RE: **13424 Cedarbrook Ave NE**
Grading and Drainage Plan
Engineer's Stamp Date: 11/27/18
Drainage File: F23D013

DRAINAGE AND TRANSPORTATION INFORMATION SHEET (REV 6/2018)

RE: **13424 Cedarbrook Ave NE**
Grading and Drainage Plan
Engineer's Stamp Date: 11/5/18
Drainage File: F23D013

WALL DETAILS AT ALL PROPERTY BOUNDARIES

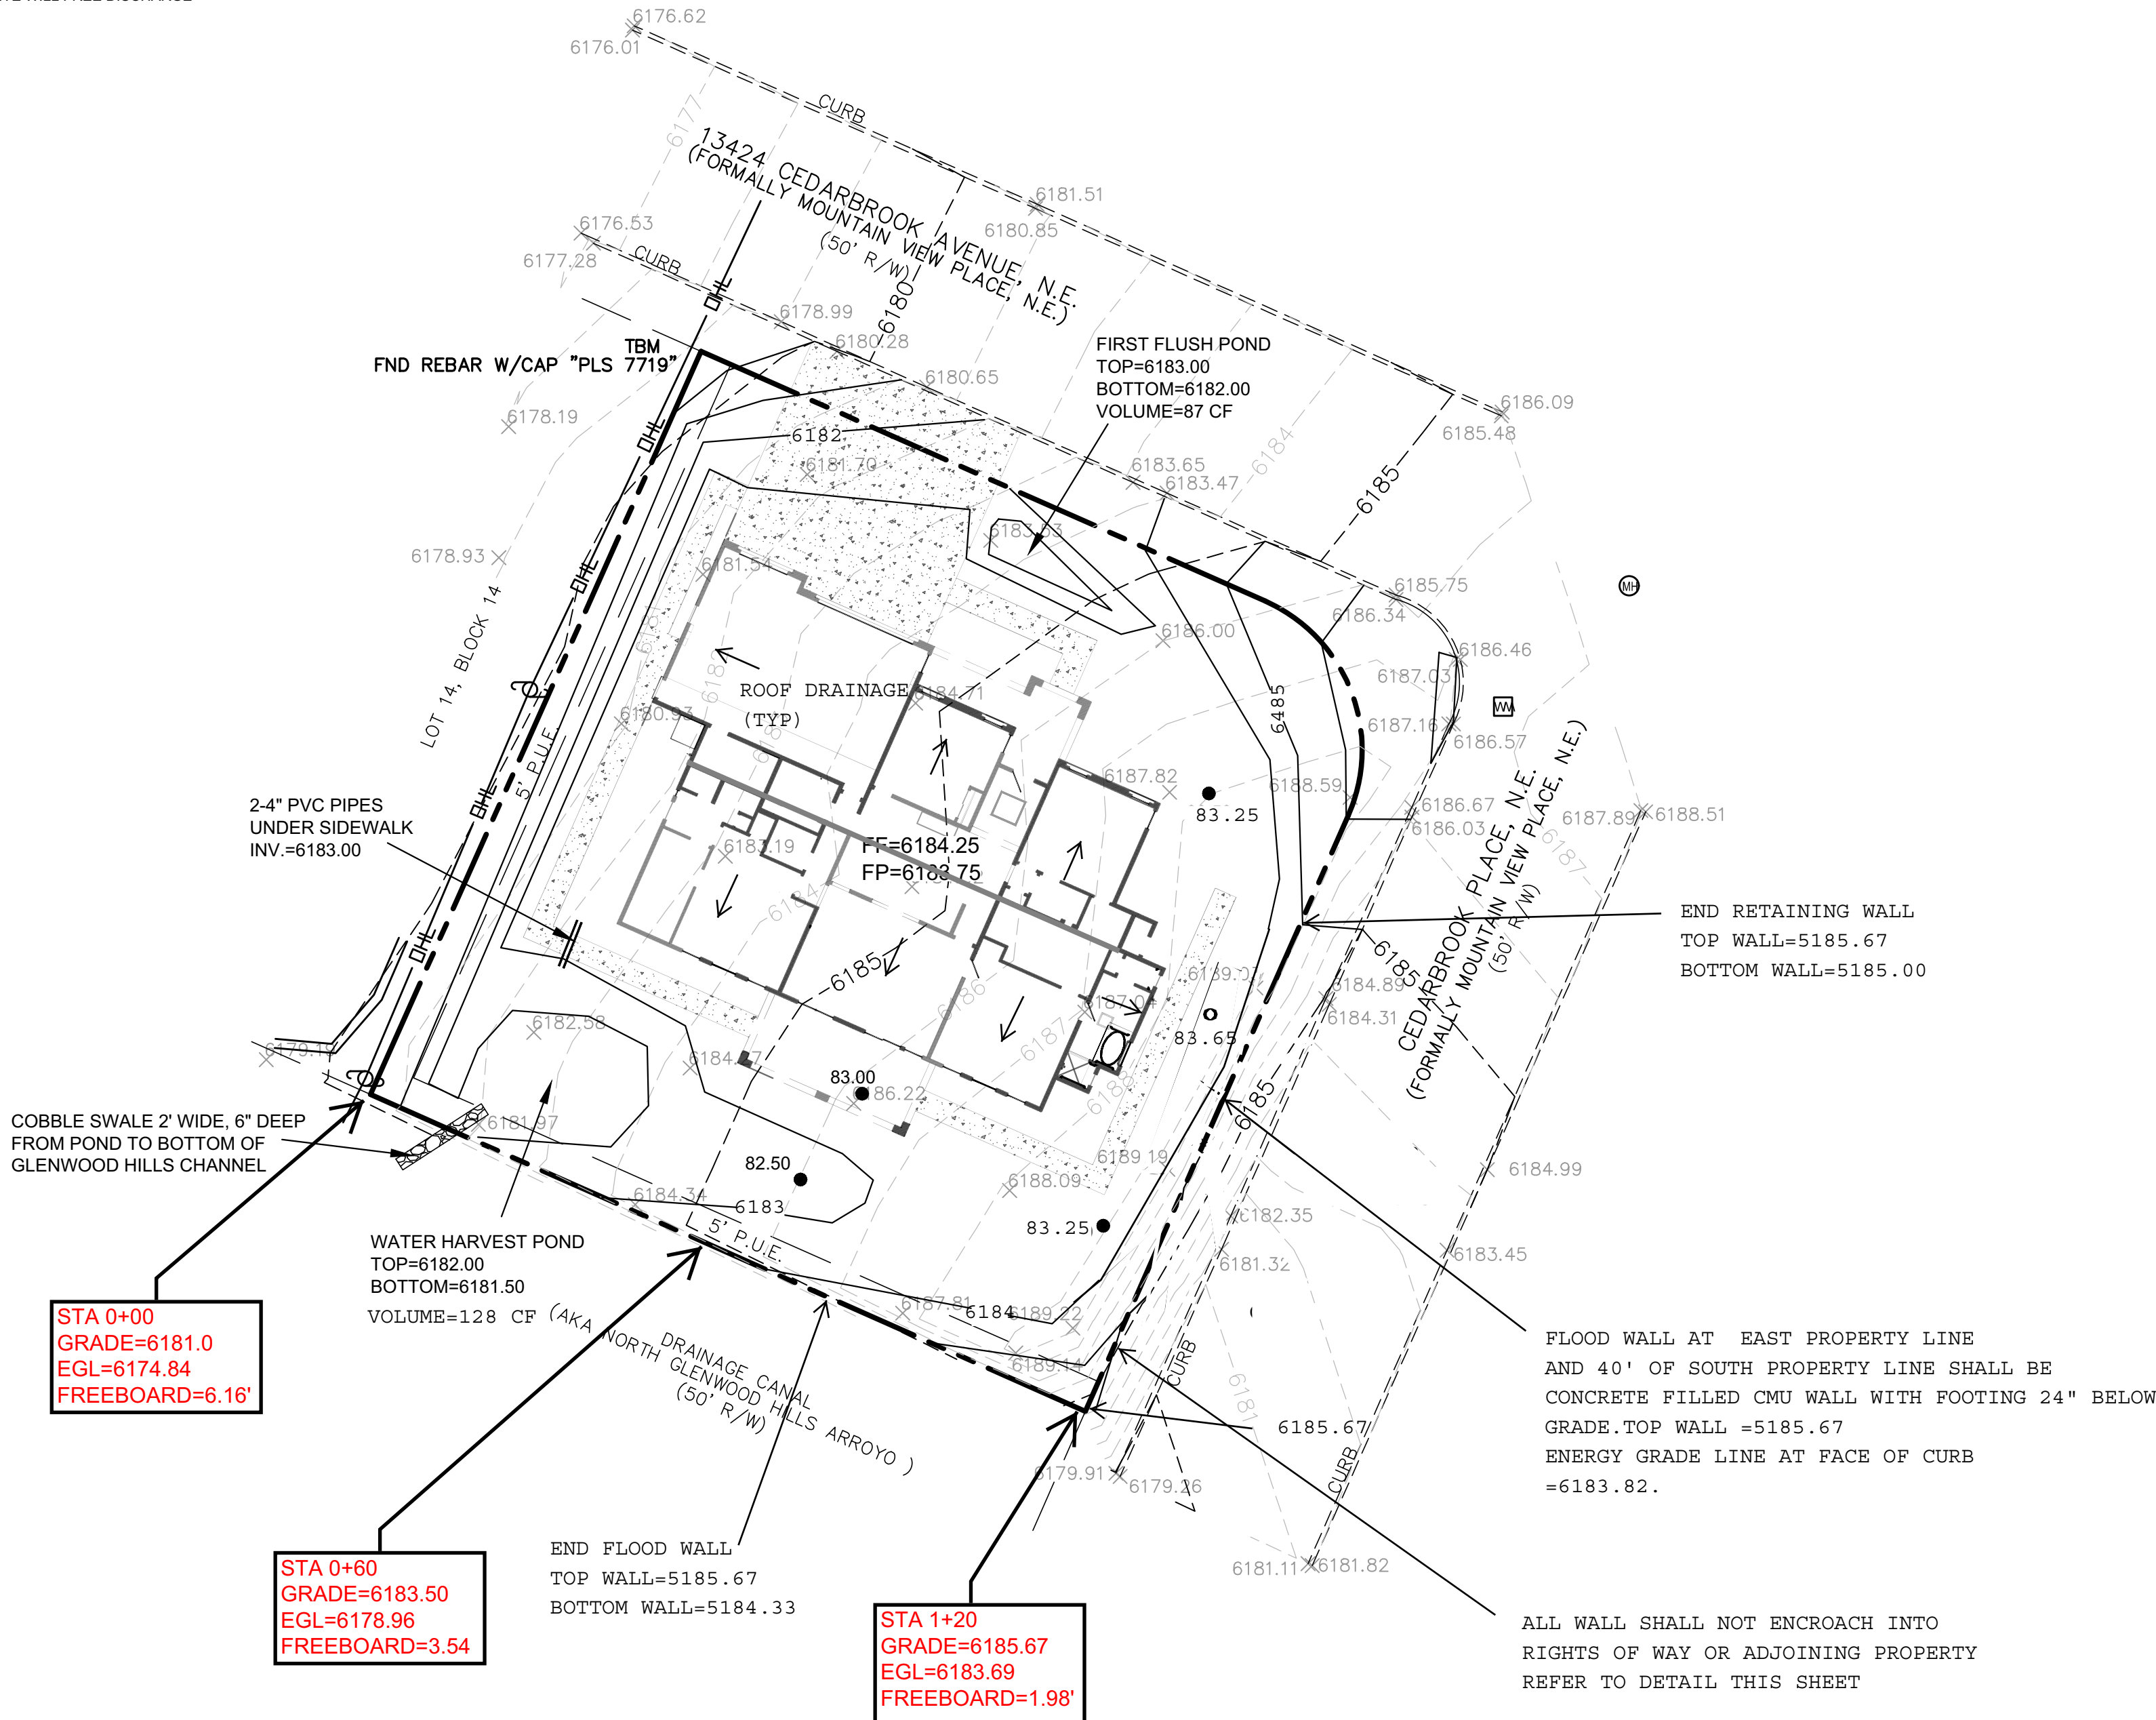
1. Show the freeboard wall in plan view and provide sections (east wall and south wall). Ensure the wall and footer do not encroach on either ROW. Any private encroachment into the public ROW will require a revocable permit.

WALL SHALL BE CONSTRUCTED SUCH THAT NO PORTION OF WALL OR FOOTING SHALL ENCRDCH. EXISTING GRADES SHALL BE MAINTAINED WITHIN RIGHT OF WAYS
